Accessibility Survey

City of Downey Boyne Street - Brookshire Avenue To Cul-de-sac

Date of Inspection
2/1/2017

Prepared By
Disability Access Consultants
(800) 743-7067

Change In Level West Of Brookshire Avenue @ 33.928584889651, - 118.140225559473

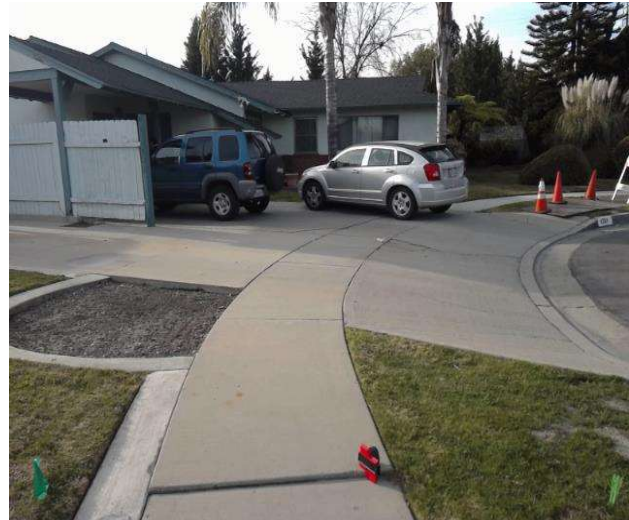
There is a change in elevation greater than recommended value.

On-Site Finding 0.75 inches

Code Reference ADA 206, 302

Ensure that the change in elevation is within the recommended value.

Recommendation Up to 0.25 inches

Tree West of Downey Avenue @ 33.928987707783, -118.141563981771

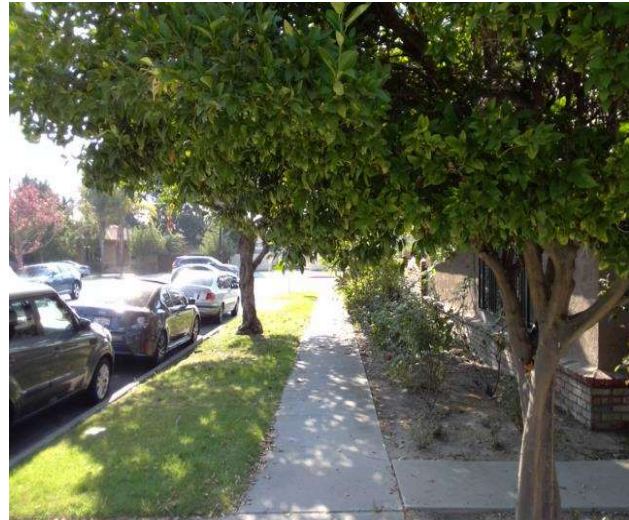
Overhead obstruction height is not compliant.

On-Site Finding 64.00 inches

Code Reference ADA 206, 307.4,CA 11B-307.4

Provide a compliant vertical clearance height.

Recommendation At least 80.00 inches
